Technical Service Bulletin

72 Noises from the second row seats

72 20 29 2060719/1 October 5, 2020.

Model(s)	Year	VIN Range	Vehicle-Specific Equipment
Q7, SQ7	2017 - 2022	All	Not Applicable

Figure 6. Adjustment of outer locking plate.

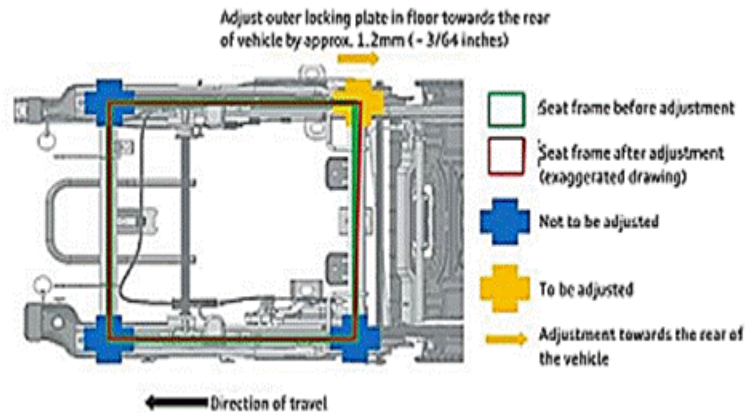
- Loosen both bolts of the locking plate and then move the locking plate evenly towards the rear of the vehicle by approximately 1.2mm (~ 3/64 inches) (Figures 5 - 6).

**Tip:** Mark the location of the locking plate prior to loosening the bolts.

- Tighten the locking plate bolts according to the repair manuals and reinstall the locking plate trim.

Warning: Do not add tape or any other material to the locking plate. Adding tape/material could negatively affect the function of the seat latch and thus result in serious personal injury or death!
